Attachment A Response to Submissions

Horsley Drive Business Park Stage 2 – Building 1
State Significant Development Application
SSD 10404

25 June 2020 | 2190880

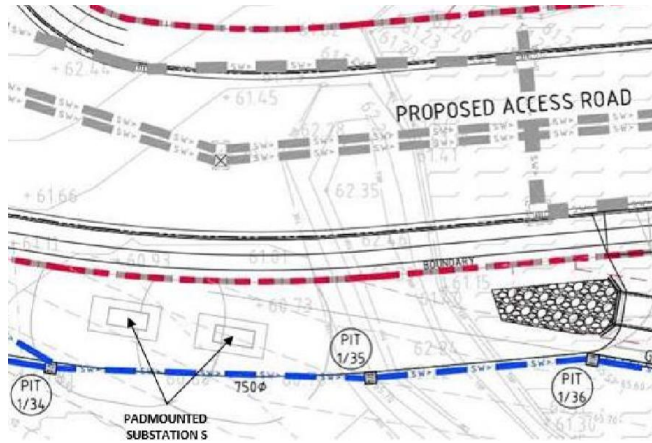
Endeavour Energy has also noted that as shown in the following extract of the Civil Engineering Drawings that provision has been made for two padmount substations on the site.

From Endeavour Energy's perspective the fact that provision is being made for the substation is a positive. As previously advised, as a condition of the Development Application consent the Department should request the submission of documentary evidence from Endeavour Energy confirming that satisfactory arrangements have been made for the connection of electricity to the proposed development, prior to the release of the Construction Certificate / commencement of works.

A method of supply will be provided via Network Connections Branch when a load application is received.
